[Journal of Information Processing]

Title: Communication Overhead Description Schema for Multi Core Processor in Model-based

Development

Authors: Yue Hou, Yutaro Kobayashi, Hiroshi Fujimoto, and Takuya Azumi

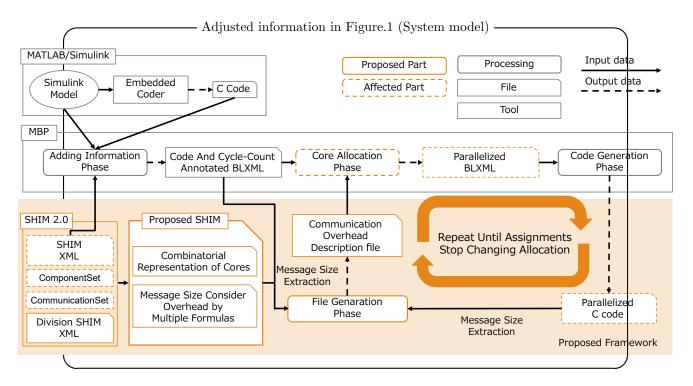
I wonder why the Parts for ComponentSet and CommunicationSet, which could be seen in the title of the sub-sub-section, did not appear in Figure 1 as seen in the title of the other sub-sub-section.

In response to the review, we have updated Figure 1 to include the parts for ComponentSet and CommunicationSet. We also made minor modifications to the original system model and have clarified once again that our proposal builds upon the existing SHIM framework. We appreciate your insightful comments which have guided these enhancements. Thank you for helping us improve our work.
